FARRAGUT MUNICIPAL PLANNING COMMISSION

AGENDA

June 16, 2022

5. Discussion and public hearing on approval of a preliminary plat for the Westerly Subdivision, Parcels 8.01, 9, and 10.02, Tax Map 152, 8.74 Acres, 12 Lots, Zoned R-1 and R-2 (BHN-P, Applicant)

GRADING & DRAINAGE PLAN FOR
WESTERLY SUBDIVISION

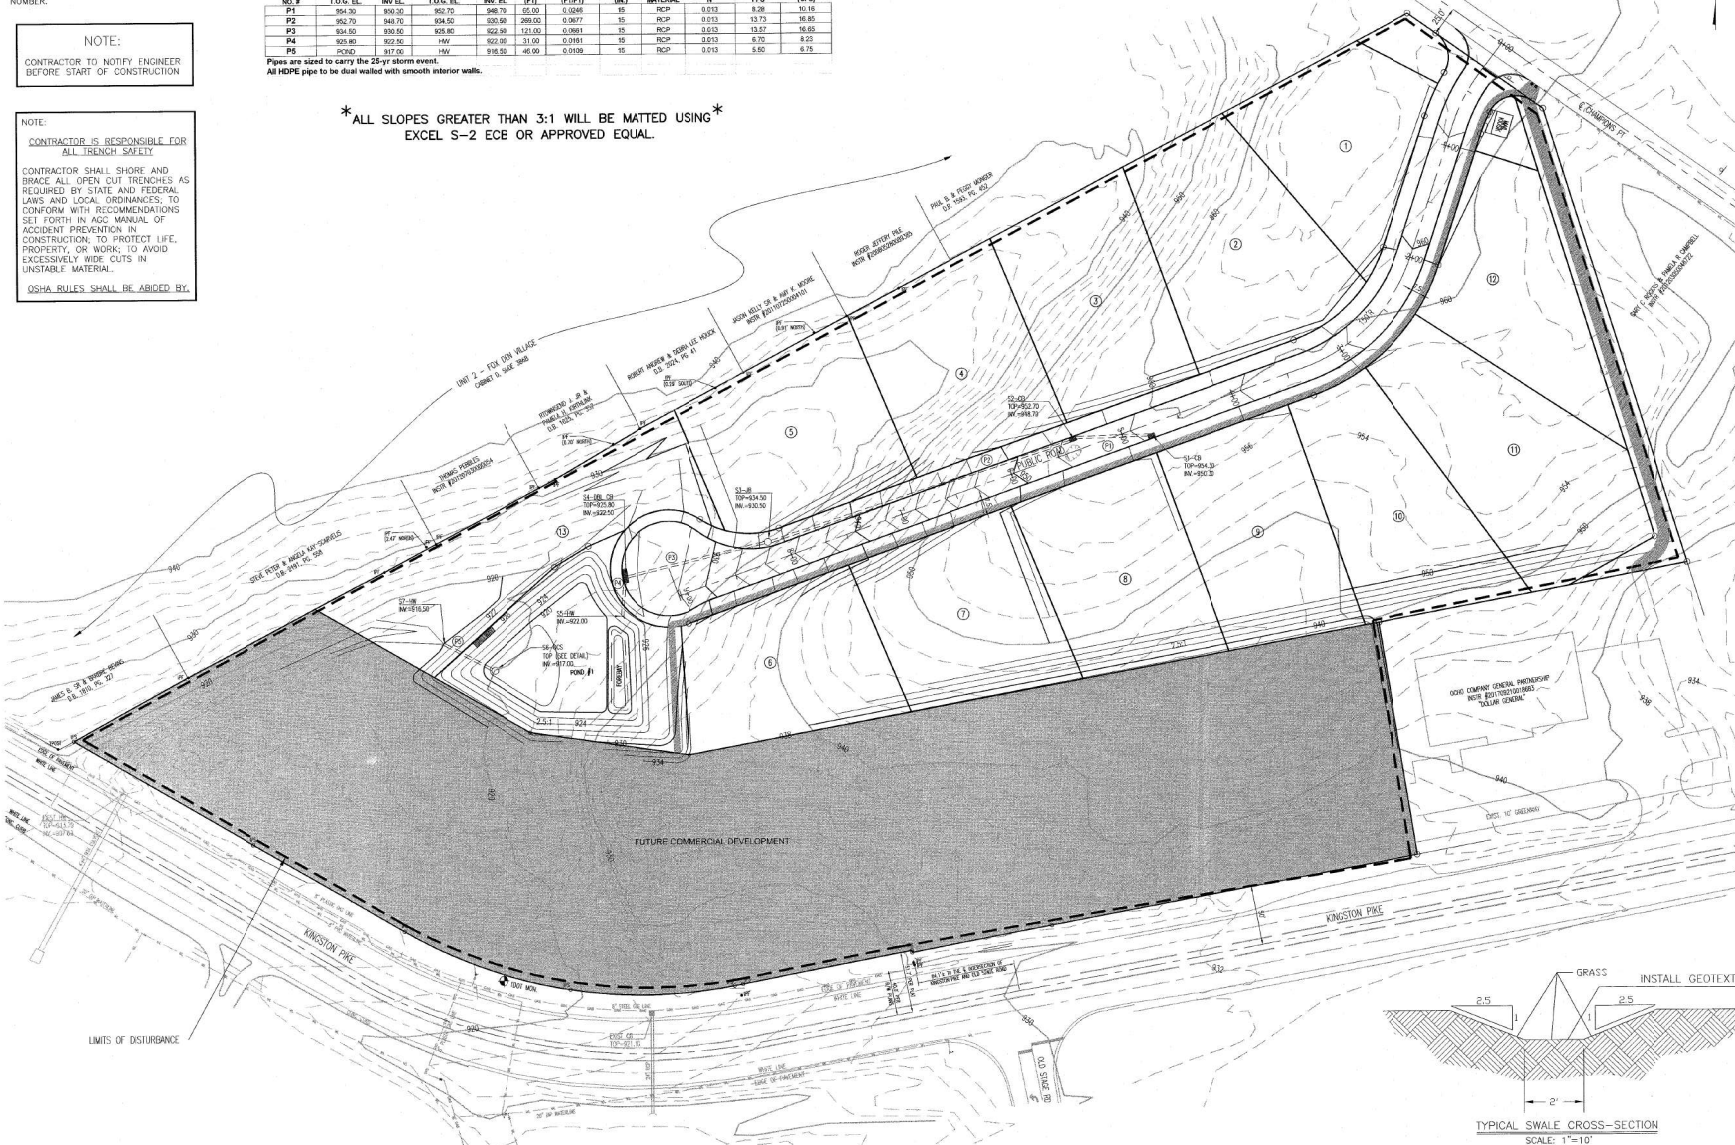
Please verify elevations for sediment pond. A table of elevations would be helpful for both staff and grading contractors.

Pond bottom is 917.00 for detention, but 918.00 as sediment pond. Is that correct?
Is 918.75 the cleanout elevation or top of wet storage? Three (3) feet of wet storage should be provided per BMP manual.

POND #1

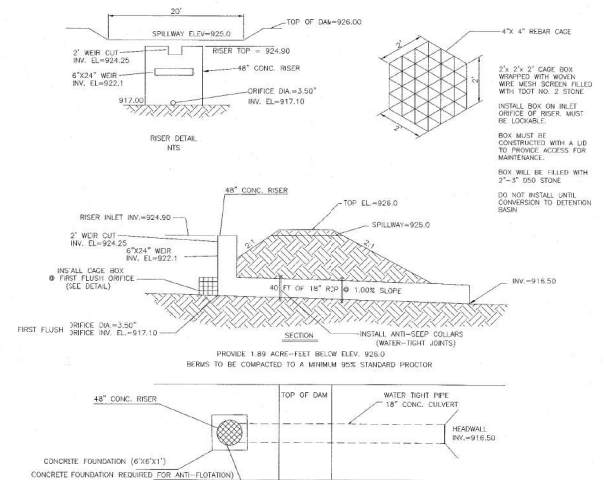
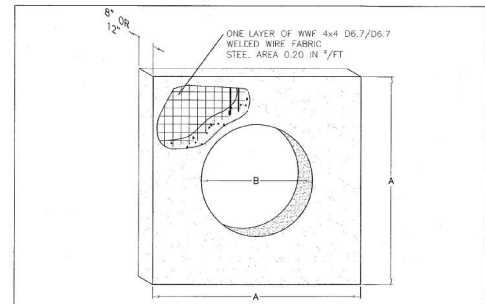
Please submit a stormwater maintenance and repair plan for the detention basin. An example plan will be provided.
